Nuclear Energy Institute

**GUIDELINES FOR
PRIORITIZATION AND
SCHEDULING IMPLEMENTATION**

DRAFT

April 2014

Figure 1-1
Plant Process for Schedule Prioritization

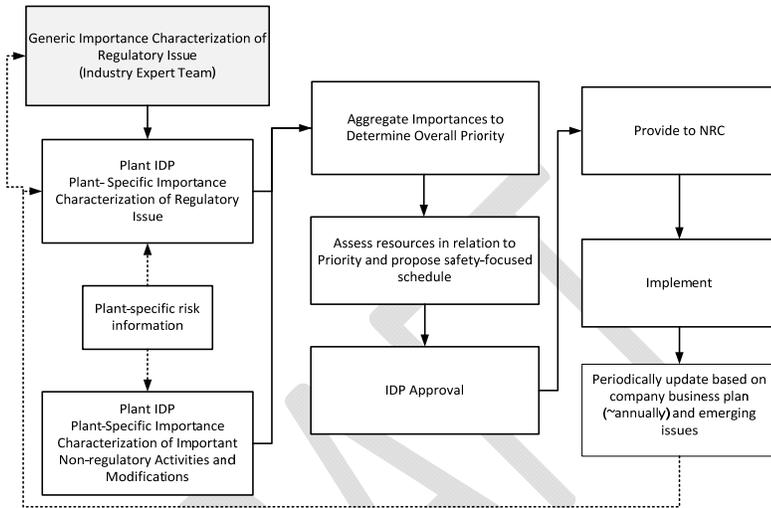
Comment [F13]: If a plant-specific non-regulatory activity with safety implications has generic applications, is there a provision for the GAET to be informed by the IDP? If a determination made by the GAET can be better informed by IDP considerations (e.g., IDP identifies additional aspects that could impact the overall priority characterization that GAET did not consider and could have an impact for other site IDP considerations) is there an early feedback loop (currently, this feedback appears to occur at the end)?

Figure 3-1

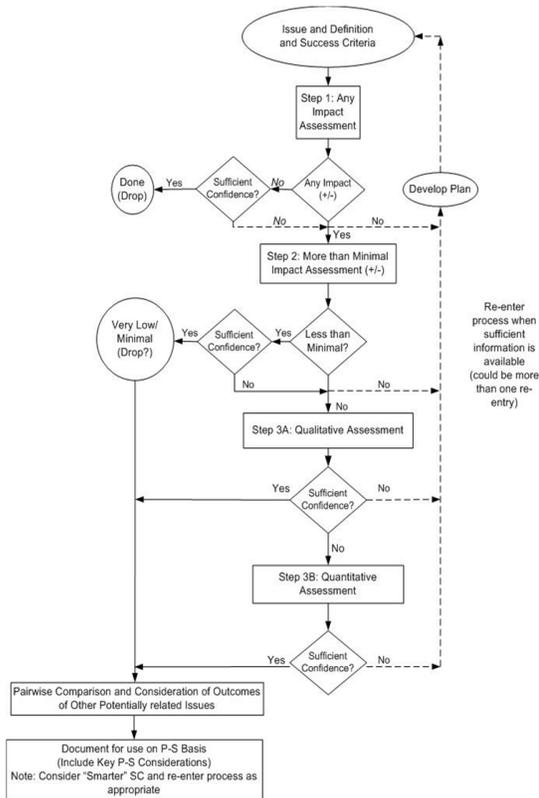
Comment [F64]: This figure includes an option to drop an issue (including a regulatory issue). As currently discussed, there isn't an envisioned mechanism by which an NRC requirement would be voluntarily dropped by an external industry panel. Even if information exists that support the assessment that there is absolutely no nexus to safety enhancement, this should be discussed with the NRC through appropriate processes.

Figure 3-2

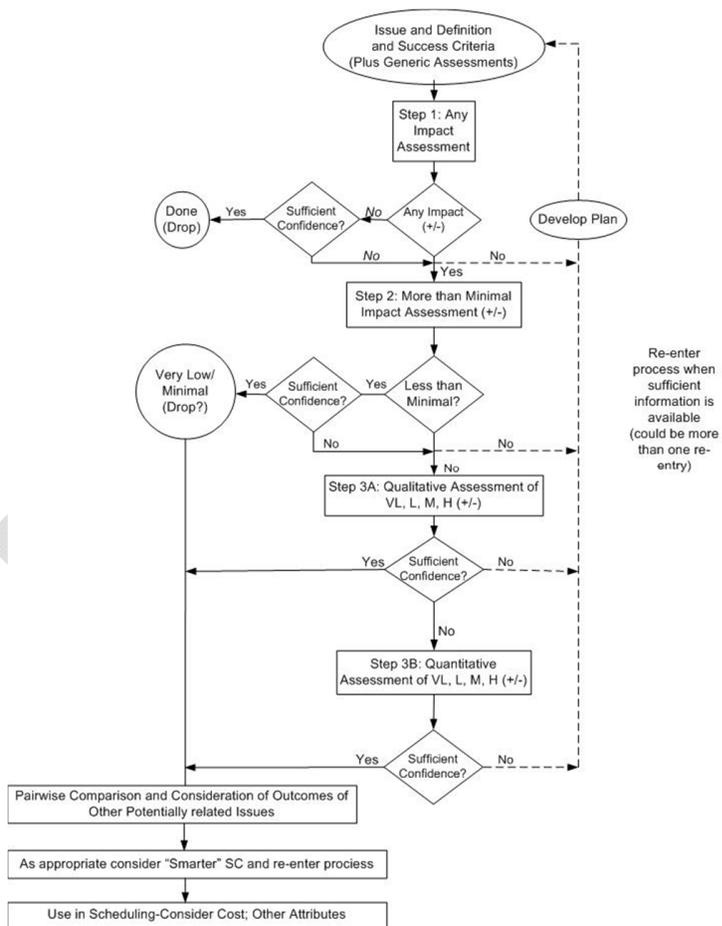
Comment [F65]: As identified in the previous figure, the same comment on drop option applies here.

Figure 4.1-1

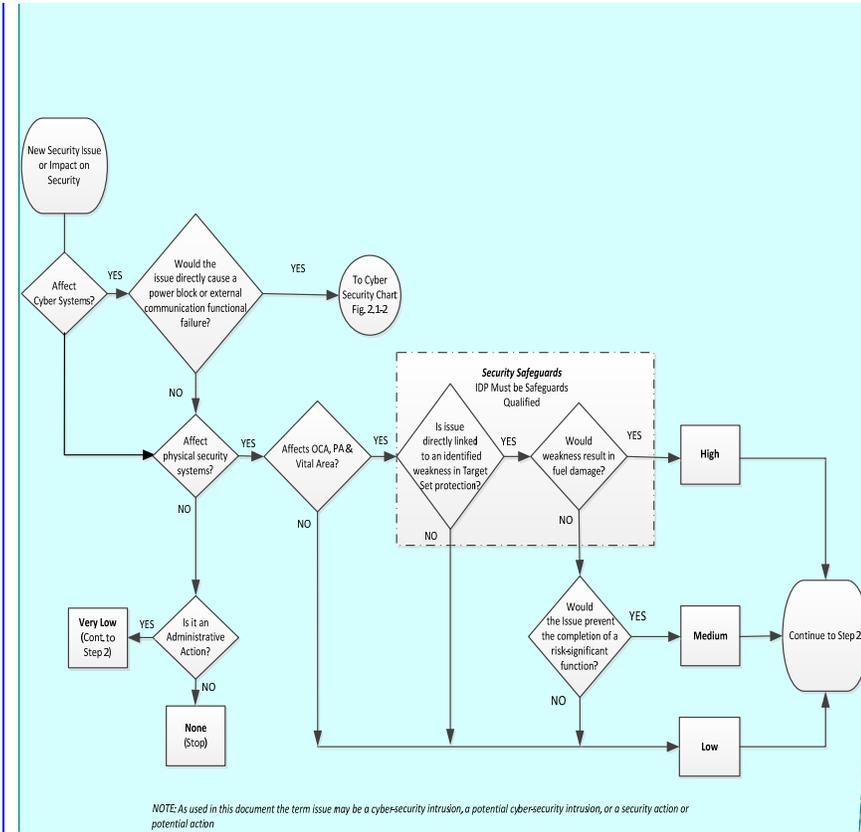
Comment [M85]: Where is the "sufficient confidence" which seem even more applicable to security, blocks that are incorporated into the safety flowcharts.

Figure 4.1-2

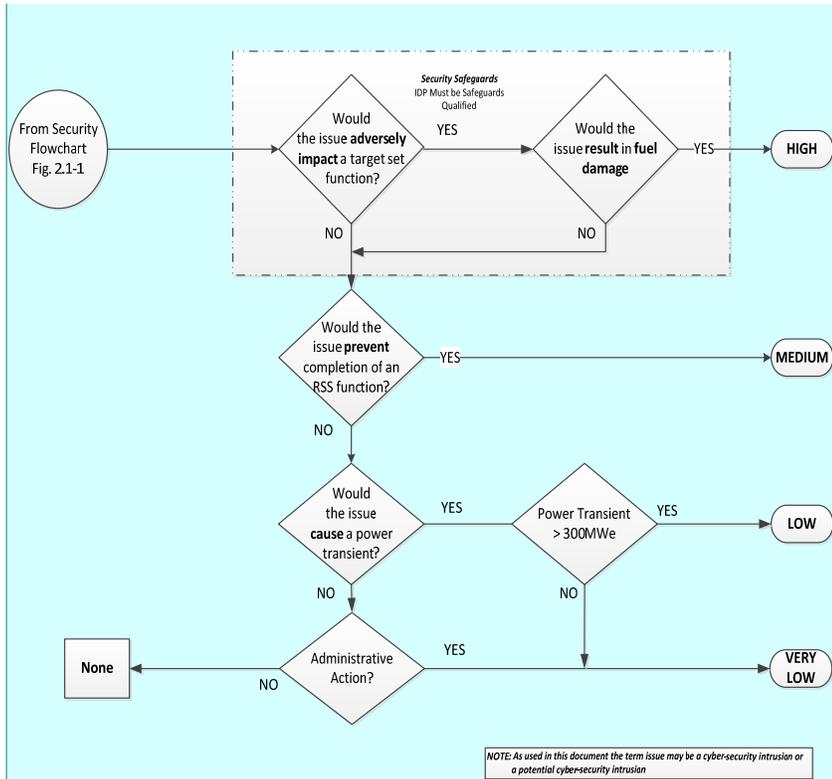
Comment [M88]: It appears that a Cyber issue with the potential to make the external or internal communication system not function properly goes to none. That wouldn't be appropriate.

Figure 4.2-1

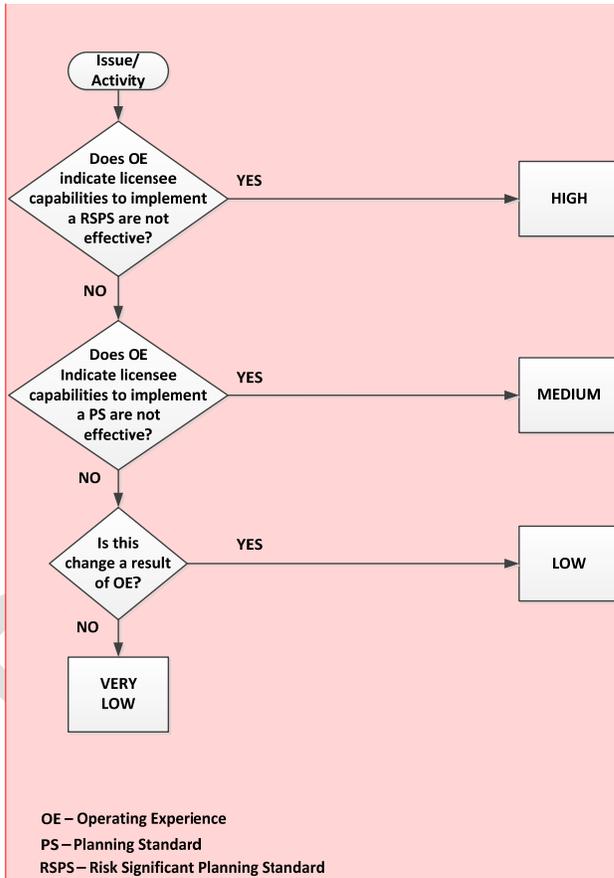
Comment [AMZ90]: New EP Flow charts were developed. This is no longer up to date.
